# COUNTY OF ALAMEDA

## ADDENDUM No. 2

Project No. 14030

Santa Rita Jail ADA Phase 0 Ramp

Project No. 14030, Addendum 2 - Attachment 1

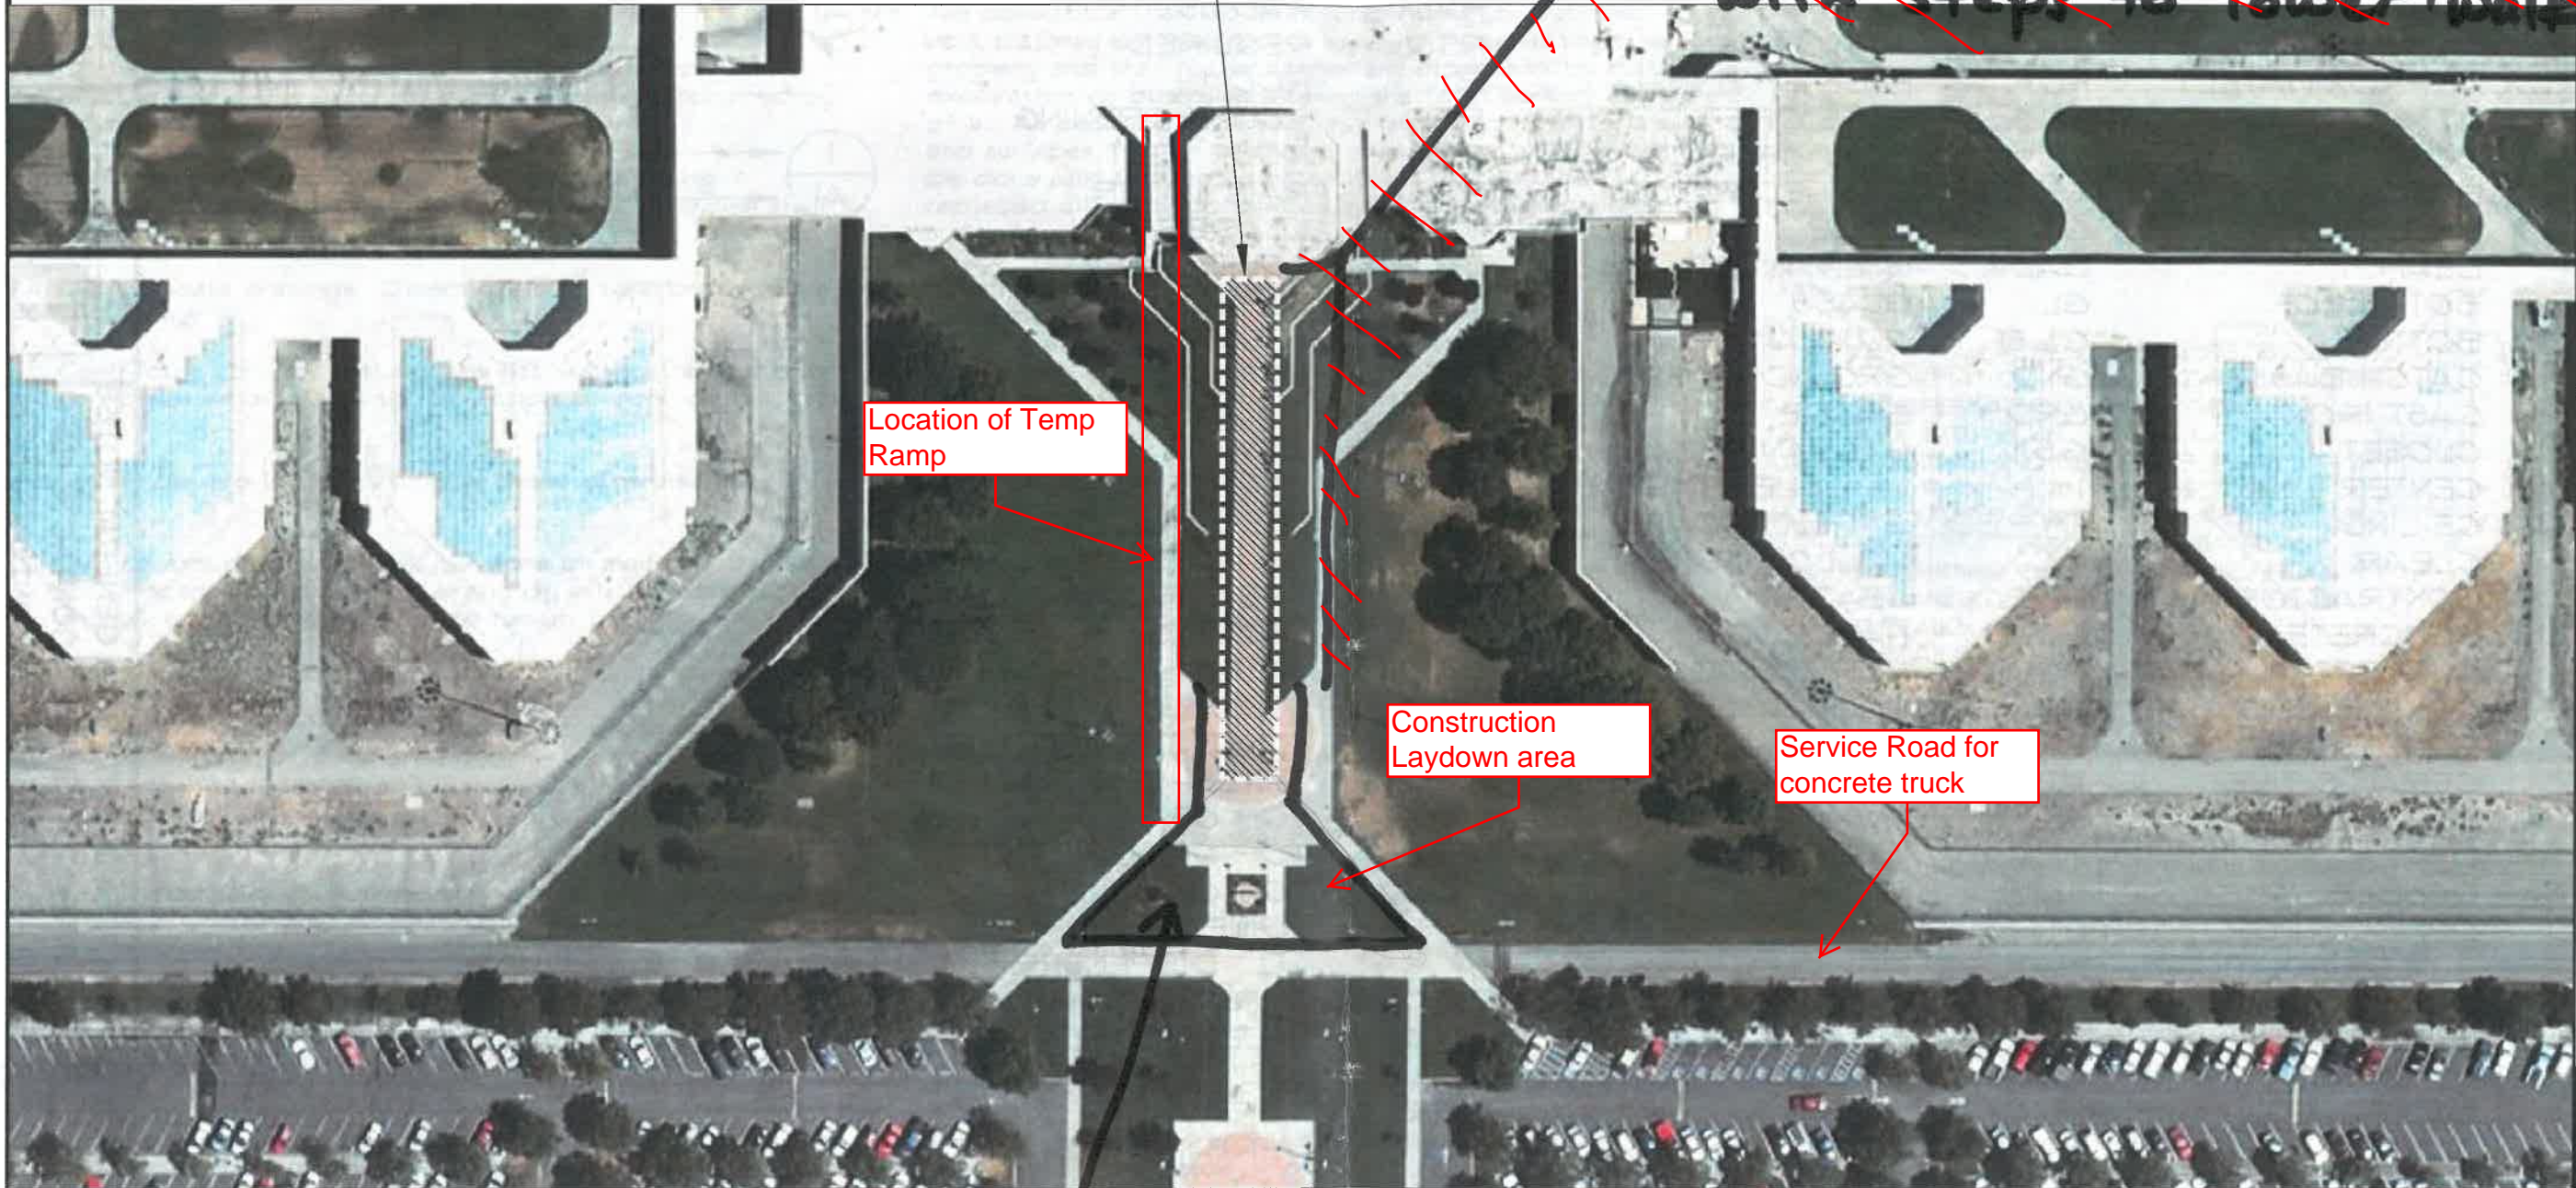
*Q7. Please clarify exposed aggregate finish. Is this a natural wash or seeded aggregate? If so, what type of aggregate (size, color) and then washed. Please see attached A1.3 with notes.*

**A7. Exposed Aggregate finish is seeded and washed. Aggregate is to be river rock, approximately 3/8" max size, gray mix with some dark/black. See Attachment 1, in this Addendum 2 with photo for reference as an example. Architect will work with Contractor to achieve best match to photo.**
